GMS Trims Ltd.

25th October 2021

Observations

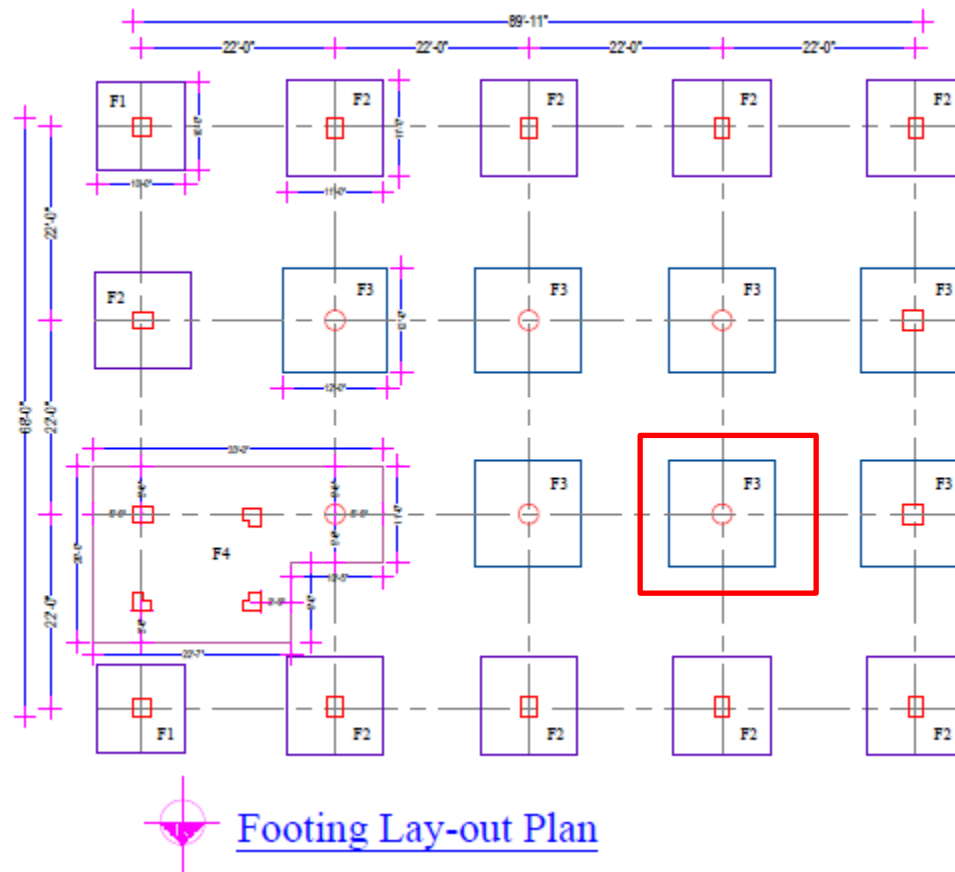
Foundation level-10 ft.
 Sylhet sand compaction-5ft
 So, we consider the bearing capacity at 15 ft. level & load transfer angle through sand is 30°
 So the effective area to transfer the load at 15 ft level is for,

F1-15.75'x15.75'
 F2-17.75'x17.75'
 F3-19.75'x19.75'
 F4-22.75'x21.42'
 F5-16.75'x16.75'
 F6-17.75'x17.75'
 F7-18.75'x18.75'

The Foundation is an RCC Footing system, footing bearing capacity is taken from soil test report table no-1 for trims existing building, table no-1 for trims extension building.
 15' bellow from EGL

Trims existing building
 BH-1=2.32
 BH-2=2.61
 BH-3=2.46

Avg.=2.46 Tsf (F.S=3.0)

4.92 ksf for F.S=3.0.
